21150 PCI-to-PCI Bridge

Specification Update

October 2001

Order Number: [278258-009](#)

Figure 1. S_Clock Multiplexer Workaround Circuit for Errata 6.

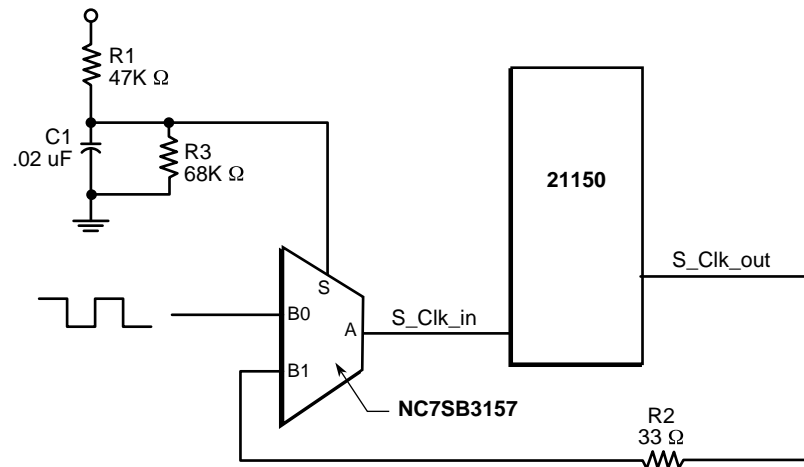
1. [Figure 1](#) illustrates the first recommendation - a circuit where an on-board pulse source is gated via the B0 input of the multiplexer to the `S_Clock_in` pin of the 21150.

At time 0, the S input of the multiplexer is low, allowing pulses from the on-board pulse source, connected to the B0 input, to be provided to the 21150 `S_Clk` input pin. When the time determined by the R/C network is satisfied, the S input pin will be in a logic High state. The Multiplexer will then shut off the input pulse from S0 and will direct the `S_Clock_out` pulses via the B1 multiplexer input, into `S_Clock_in`.

The values used for the R/C network should be selected to allow a minimum of 2 pulses to be delivered to the 21150 after V_{dd} has reached 3.0V at a frequency not to exceed the appropriate PCI component. i.e. 30 ns for a 33Mhz bridge. These values should be chosen based on the rise time of the power supply and the frequency of the on board pulse source. The values given for R1, R3, and C1 are for example purposes only.

Note: The NC7SB3157 2:1 Multiplexer / Demultiplexer Bus Switch used in this example has a maximum propagation delay of 800ps that should be taken into consideration when matching trace lengths of the clock lines to avoid introducing excessive skew in the clocks. All S_Clock etch lengths must be matched to within 2ns @ 33Mhz or 1ns @ 66Mhz. The addition of this circuit requires that the etch length for the S_clock_in signal be reduced to compensate for the 800ps delay.

Figure 2. Recommended Circuit for a Tristable Buffer

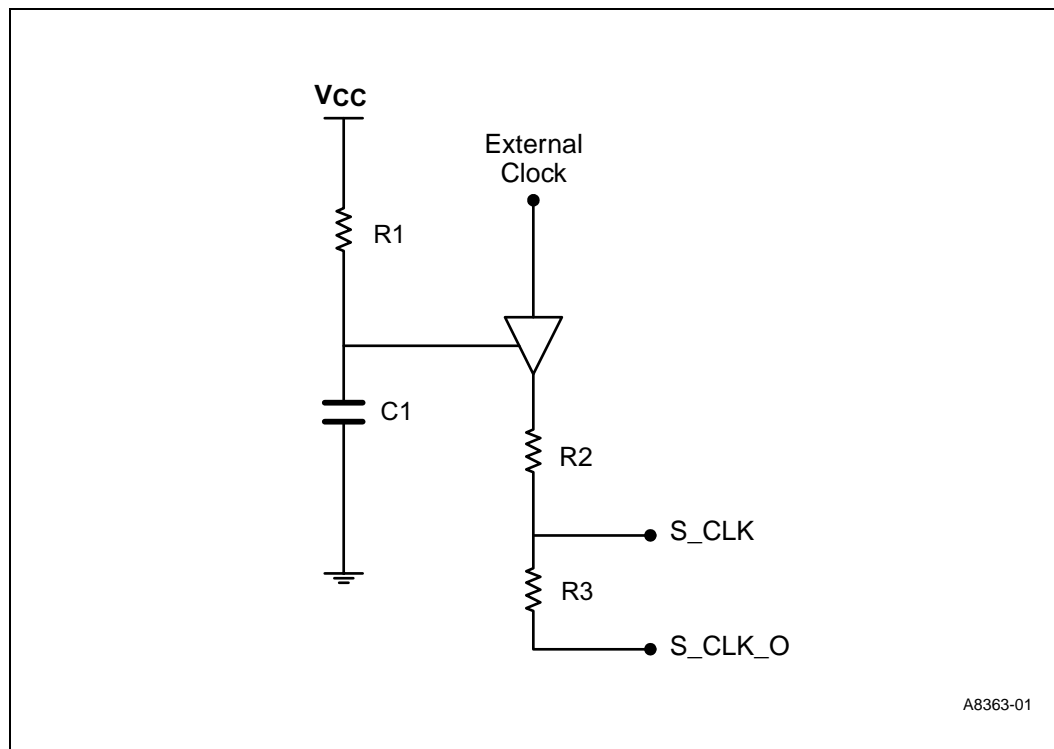
3. In the third recommendation, to guarantee the proper initialization of the s_clk circuits the addition of an external circuit that would provide a minimum of two transitions on the s_clk input during the power-up ramp is necessary. This can be done using a solution that drives an external clock onto the s_clk input while 3.3V V_{cc} is ramping during power up.

Figure 2 illustrates the use of a tristable buffer to provide multiple pulses to the s_clk input. The V_{cc} ramp rate and R1,C1 time constant determine the duration and amplitude of the pulses generated during power up. The R2-R3 values are chosen based on applicable board etch impedance-matching requirements.

The following should be considered in calculating the R1,C1 time constant

- Make the time constant of the circuit as short as possible, while still ensuring that a minimum of two pulses are generated during the Vcc ramp.
- Phase delay between **s_clk_o** and the external clock should be minimized.
- Matching the external clock and **s_clk_o** frequencies to reduce contention.
- Laboratory experiments using **p_clk** as the external clock and a R1C1 time constant between 40 and 60 percent of the Vcc ramp have been successful using this configuration. However the use of **p_clk** as the external clock violates the PCI bus specification for loading of the primary clock.

1. Section 3.0, Figure 5, 21150 Pin Assignment

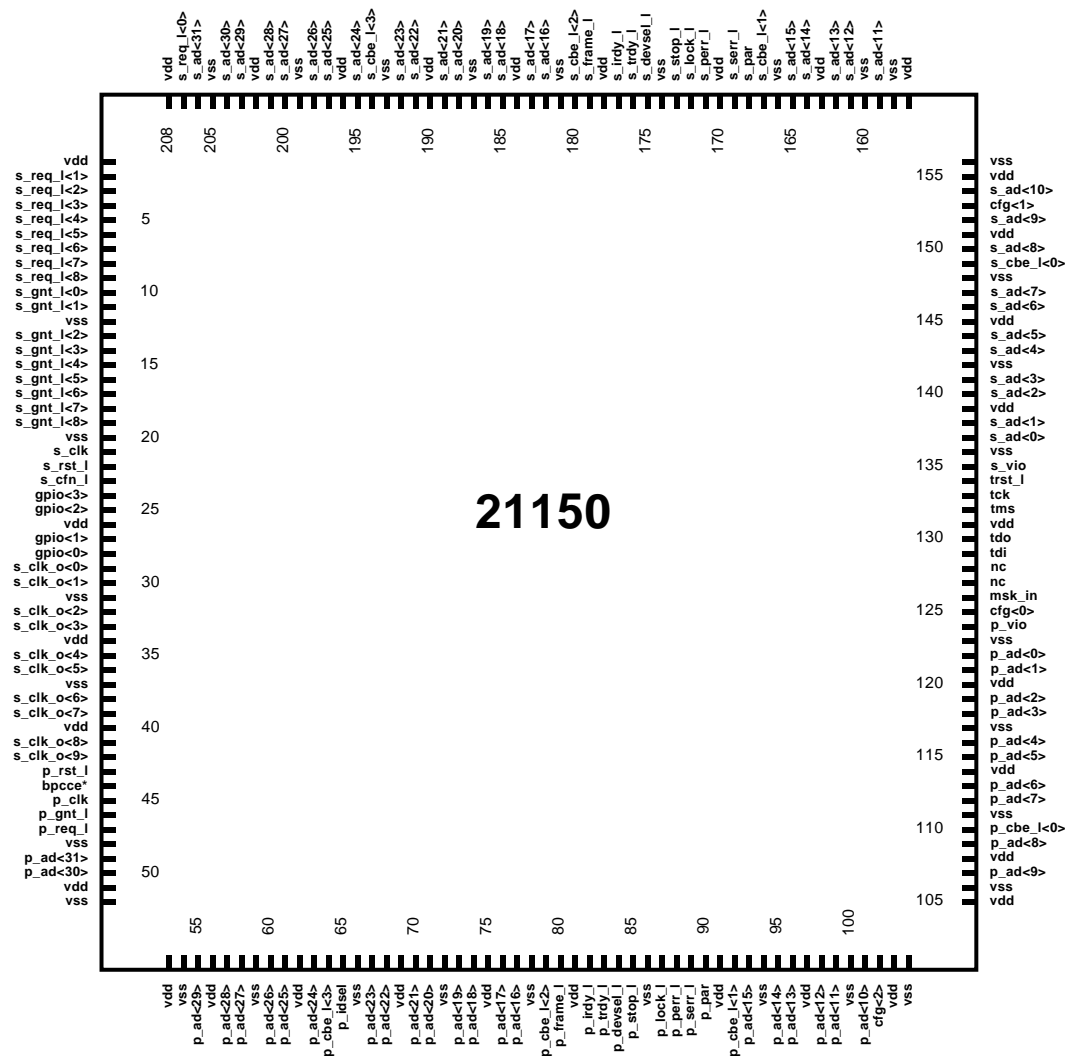
Pin 44 should be designated bpcce*. The following note should be added to the drawing: *For 21150AB and later revisions only. This is a vss pin for the 21150AA.

* For 21150-AB and later revisions only.
This is a vss pin for the 21150-AA.

Figure 20. Clock Mask and Load Shift Timing

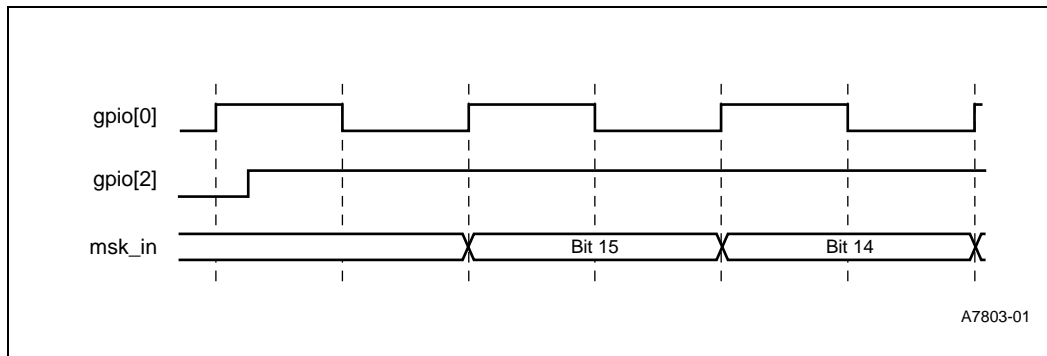
2. **Section 10.2, Secondary Clock Control, Figure 20**

This figure now appears as follows:

Figure 4. Signal trst_l States

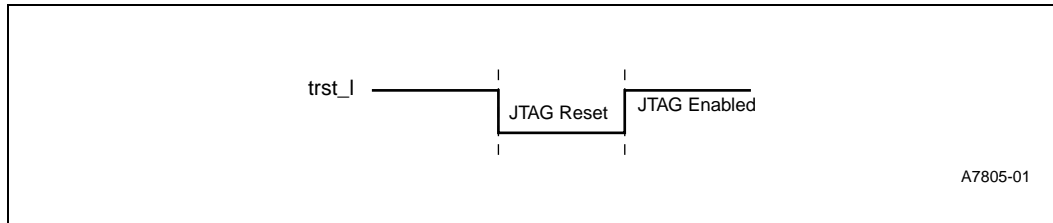
6. Section 5.1, Initialization, Description

This section has been changed to:

The test access port controller and the instruction register output latches are initialized and JTAG is disabled while the trst_l input is asserted low (see [Figure 4](#)). While signal trst_l is low, the test access port controller enters the test-logic reset state. This results in the instruction register being reset which holds the bypass register instruction. During test-logic reset state, all JTAG test logic is disabled, and the device performs normal functions. The test access port controller leaves this state only after trst_l (low) goes high and an appropriate JTAG test operation sequence is sent on the tms and tck pins.

For the 21150 to operate properly, the JTAG logic must be reset. There are two ways to reset this logic:

- The controller will reset asynchronously with the assertion of TRST_L

- The controller will reset synchronously after five TCK clock cycles, with TMS held high.

During normal 21150 operation the JTAG logic must be disabled by pulling trst_l low using a 5K resistor.

Figure 26. 21150 256 PBGA Mechanical Drawing

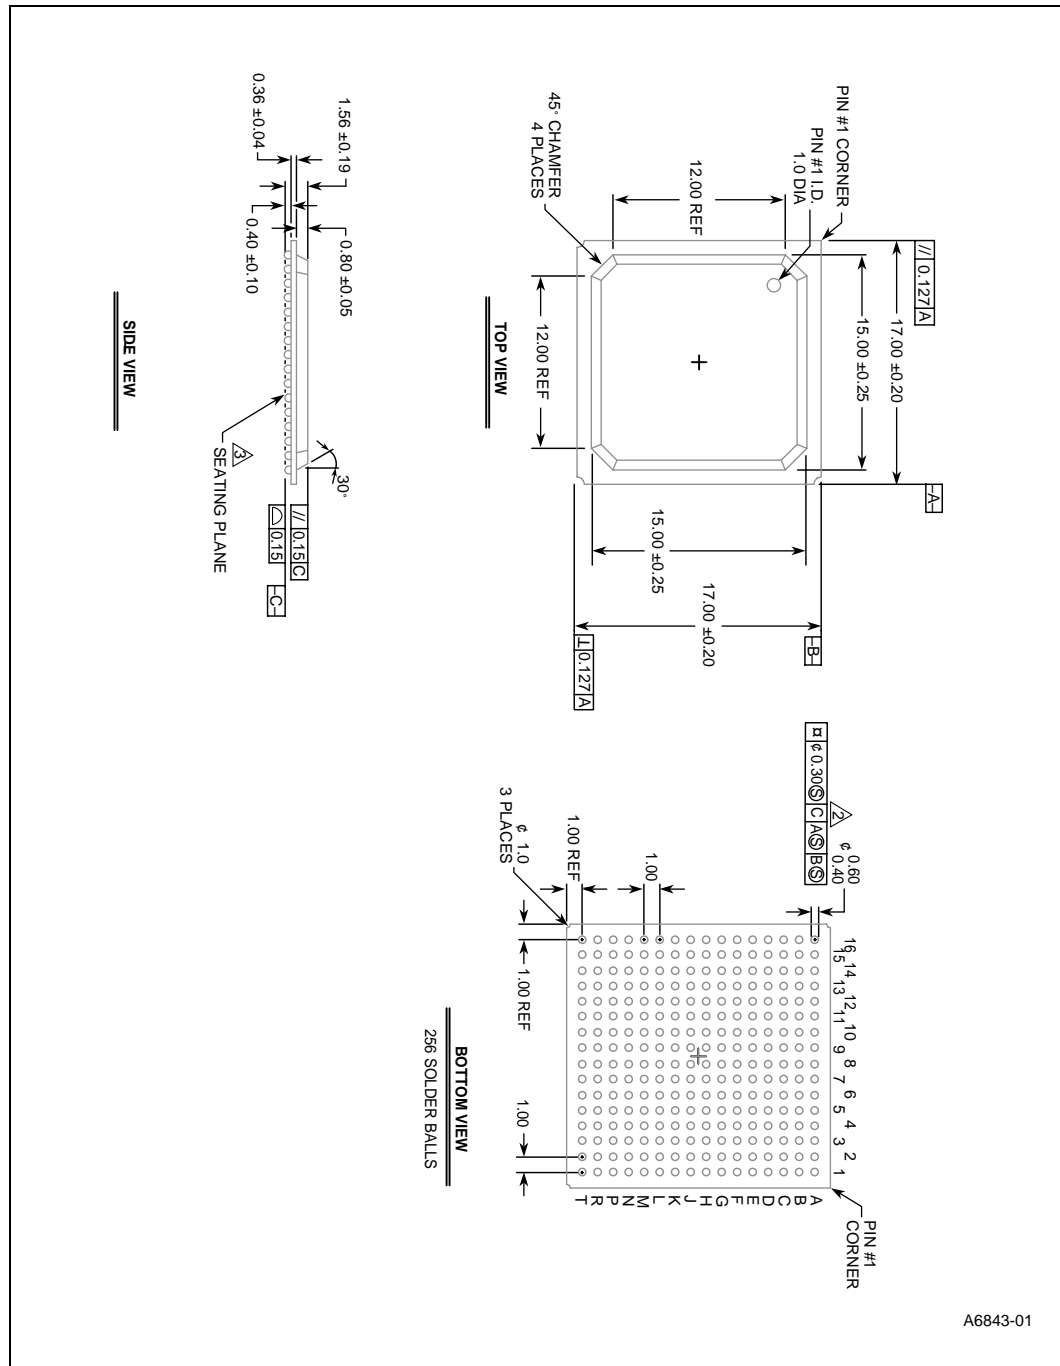
9. Mechanical Specifications: Section 18

Figure 26 and Table 51 have been added to show that the 21150 also supports the 256 pin plastic ball grid array.

Figure 2. Removal of pull-down resistor for JTAG testing

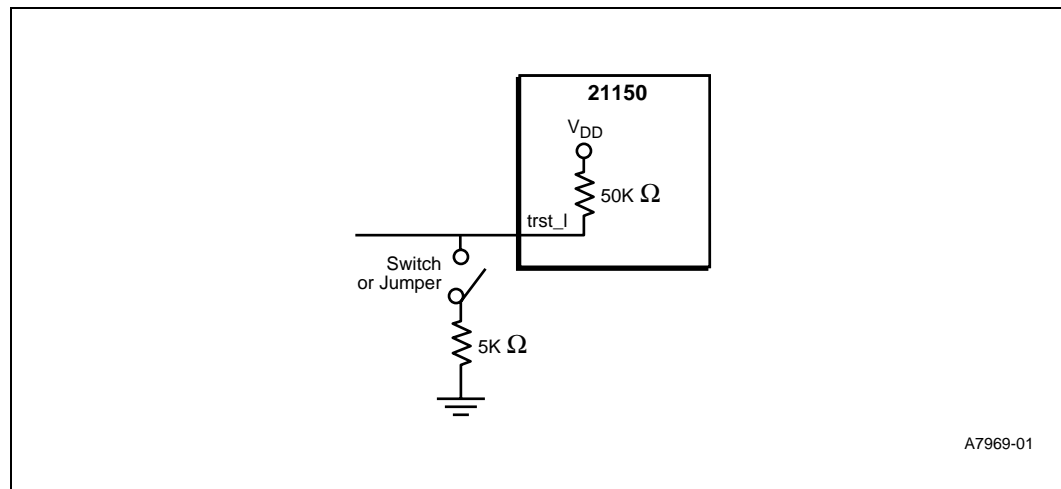
10. Section 6.3.1, Signal `trst_l` Pull-down Resistor, new section

The following new section has been added:

A 5 K Ω pull-down resistor is required on `trst_l` for normal PCI-to-PCI bridge operation. However, some JTAG test results may be inconclusive if the 5 K Ω resistor remains in the circuit. To obtain accurate JTAG results, Intel recommends one of the following solutions:

- Verify that the JTAG test equipment, after driving `trst_l` low to reset the TAP controller, constantly drives `trst_l` high during JTAG tests. If this signal is not constantly driven high, the 5 K Ω resistor will pull the signal to a low state.
- Remove the 5 K Ω resistor during JTAG tests. This resistor must be installed during normal PCI-to-PCI bridge operation.
- Design external circuits with a switch or jumper to isolate the 5 K Ω resistor during JTAG tests (see Figure 2). This switch must enable the resistor during normal PCI-to-PCI bridge operation.

Figure 19. Example of gpio Clock Mask Implementation on the System Board

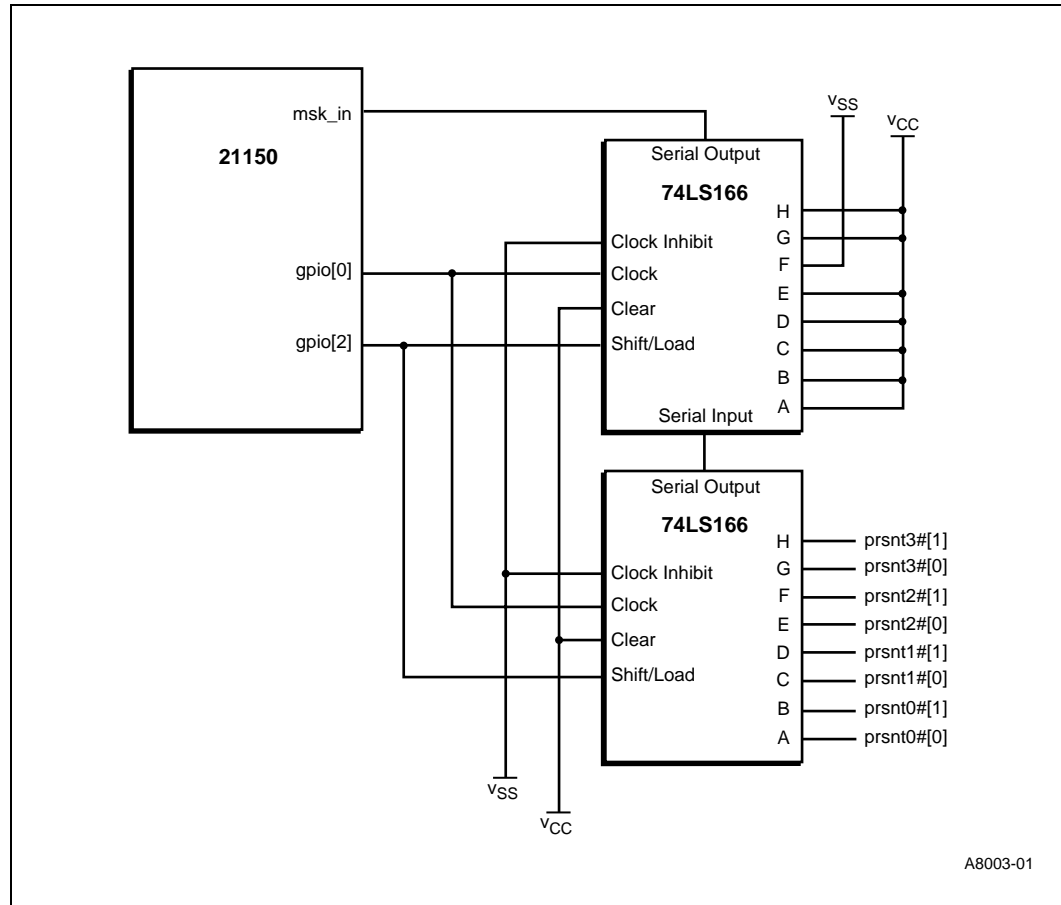
12. Section 10.2, Secondary Clock Control, Figure 19

This figure now appears as follows:
